**May 14th 2015: PRODUCT STATUS NOTIFICATION – DualVee® Integral Studded Wheels Size 4**

Bishop-Wisecarver Corporation is informing you of the obsolescence of several components from the DualVee® Integral Studded Wheel product line.

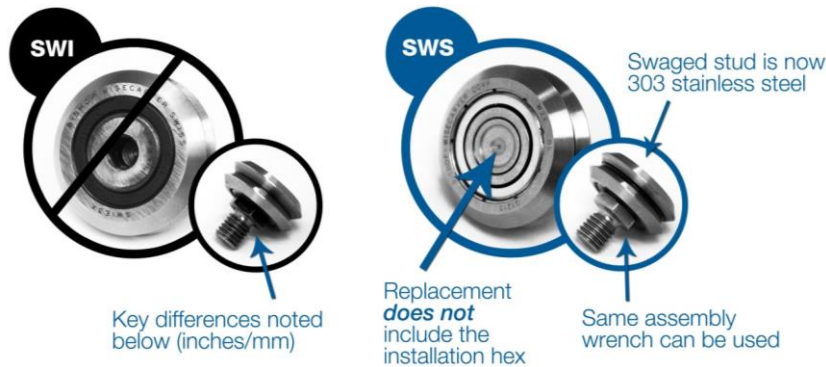
Key differences for the replacement design are listed below:

The assembly wrench will apply to both the obsolete and replacement versions. Product features which are not listed will remain the same.

Product Feature	Obsolete SWI	Replacement SWS
Stud Material	AISI 52100 Carbon Steel	SAE 303 Stainless Steel
Stud Attachment	Integral	Swaged
Bearing Protection	Sealed or Shielded	Seal/Shield Combo.
Mounting Hex	22mm (0.866")	22.22mm (0.875")
Installation Hex	10mm	None
Assembly Wrench	BAW4

BWC Product Line	Obsolete Stock Code	Replacement Stock Code	Replacement Product Description
DualVee®	SWIC4	SWSC4XA	Swaged Studded Wheel Size 4 Concentric Seal/Shield
	SWIC4X		
	SWIE4	SWSE4XA	Swaged Studded Wheel Size 4 Eccentric Seal/Shield
	SWIE4X
